Project: Casco Bay PG – Stair/Elevator Tower Restoration
Project #: WO 3604
Date/Time: June 13, 2016, 1:30 p.m.
Observers Joshua Martin-McNaughton, Author (BSE)

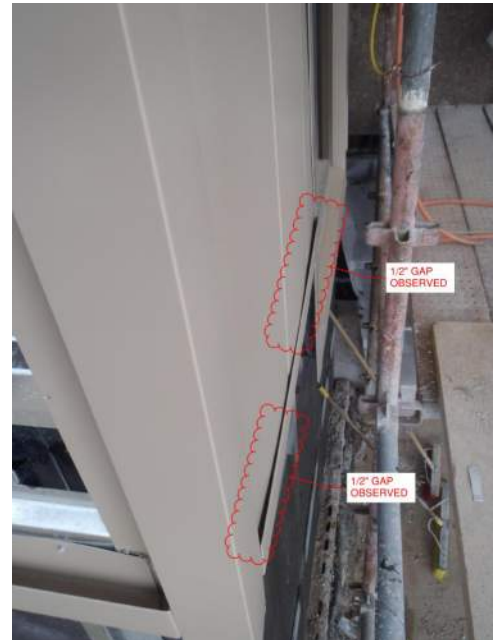
3. The fasteners securing the Z-girts to the CMU wall have had an air/vapor barrier detail coat applied to the fastener heads, see photo below.

4. The metal wall panel installers have installed the Z-girts over the elevator shaft louver, see photo above. The louver needs to be removed and reset per the shop drawings and incorporated with the wall panel system. As of 6/15/16, KISC indicated they would provide framing for the louver.
5. BSE requested that weeps be drilled into the face of the horizontal end lap flashing 16" O.C. to alleviate any water that might collect within the flashing, see photo below.
